STAFF COMMENTS FOR PLANNING COMMISSION

SITE PLAN: **AFP-06-047**

TITLE: **Observatory Heights**

REQUEST: **AMENDMENT TO FINAL PLAN APPROVAL**
For architectural model, grading, and house
footing revisions

Prepared by: G. SANKAR SUR

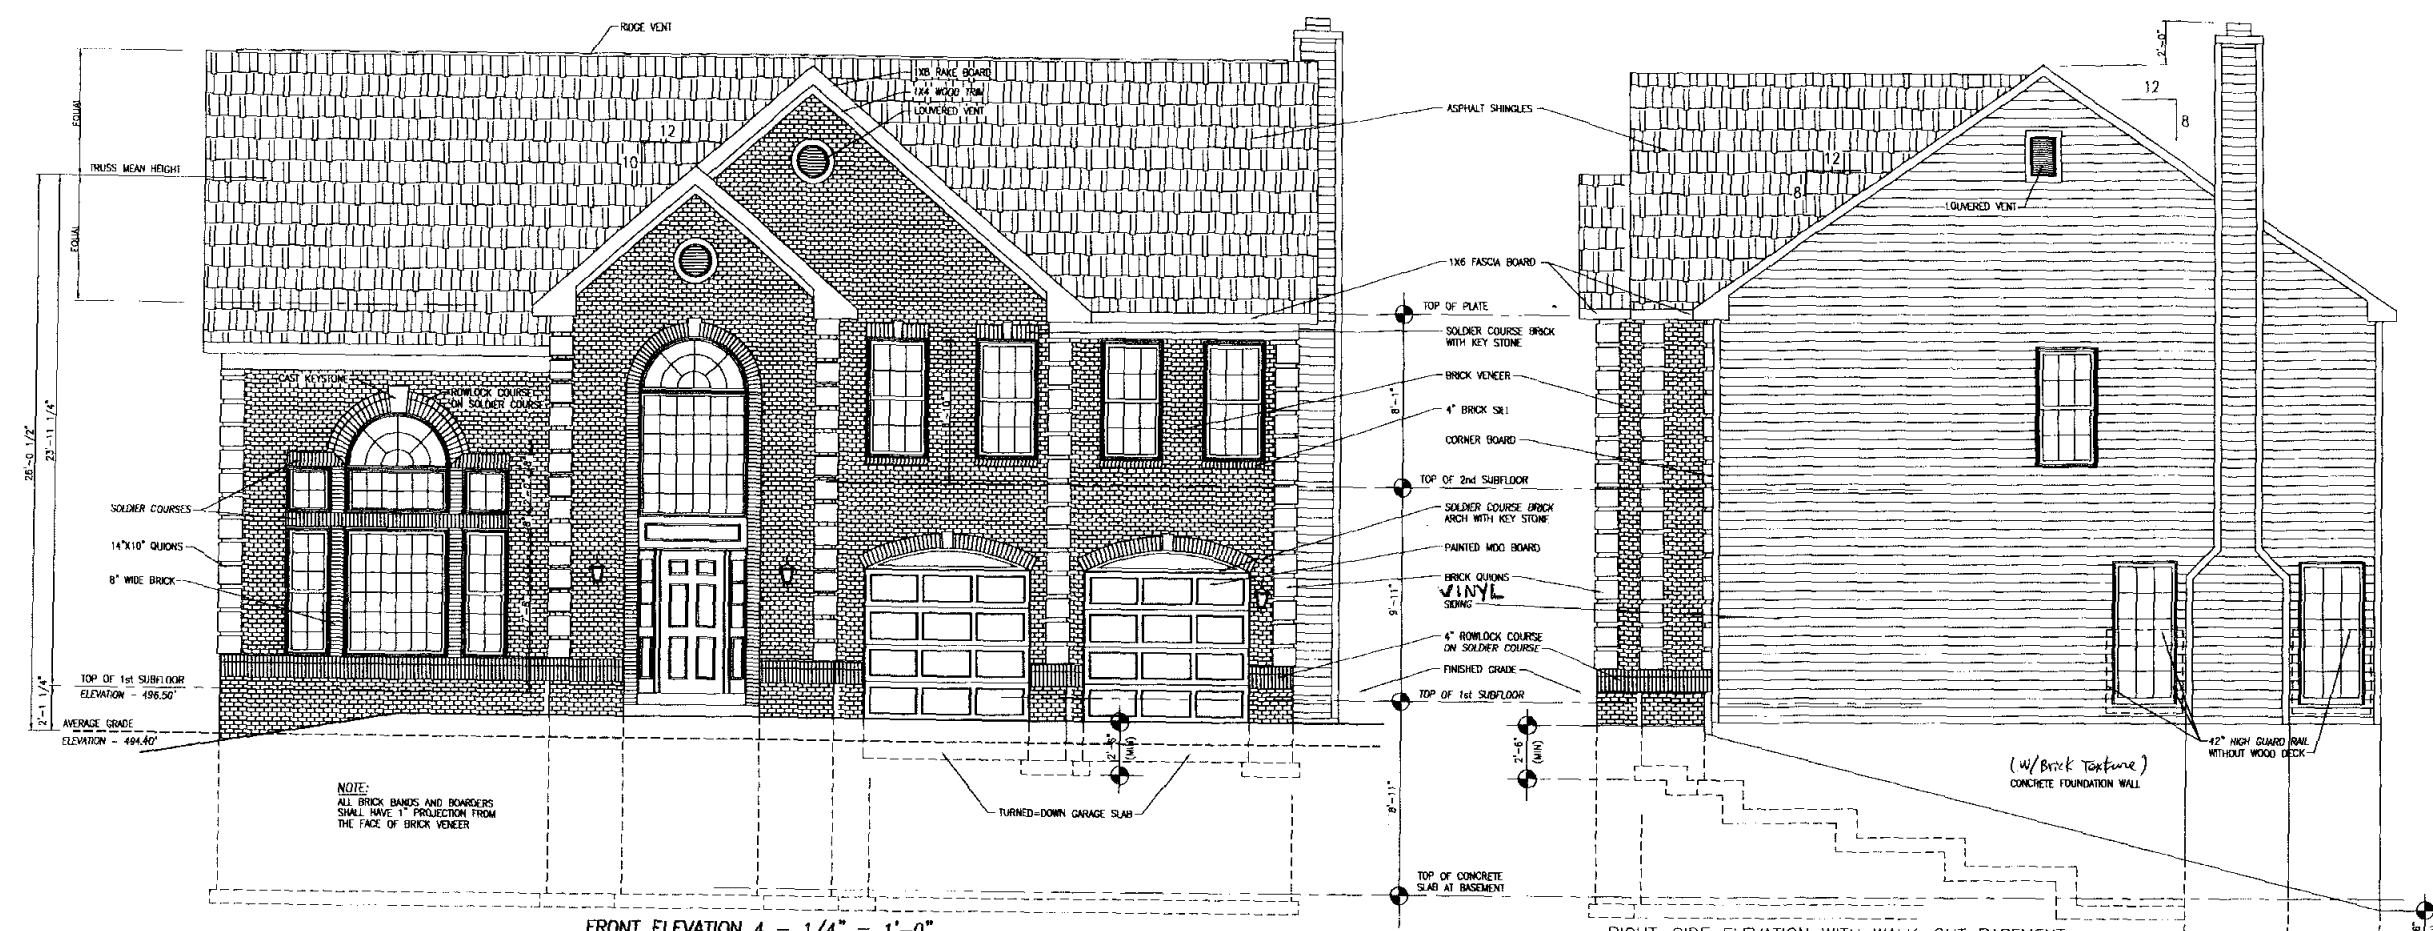
The proposed elevations and footprints of the houses on lots 91 and 92 show an increase in total square footage (Exhibits #7 and #8). The previously approved architectural elevations have been included (Exhibits #9 and #10). The square footage for lot 91 has changed from 2,439 square feet to 3,454 square feet. The square footage for lot 92 has changed from 2,439 square feet to 3,266 square feet.

The proposed architecture retains the two-story front-loaded single family detached units that were previously approved. The exterior materials and general house styles are the most prominent changes to the architecture. For both proposed houses, the front facades will have brick veneer and the remaining sides will have vinyl siding. The new architecture does not have front porches, but there is room for future decks to the sides of both houses, as shown on the site plan. The decks will not extend past the yard setback lines (10 feet on both sides). Staff is requesting the applicant revise the rear elevation on Lot 91 by changing the glass doors to windows. The doors could lead to a deck, which is not allowed at the rear of the house due to the building restriction lines.

Another notable change is the new architecture will have two double garage doors as opposed to one larger garage door. On both lots, the exposed foundation walls on the right and left elevations will be brick textured poured concrete.

- 1. The applicant shall replace the sliding glass doors with windows on the rear elevation of Lot 91.**
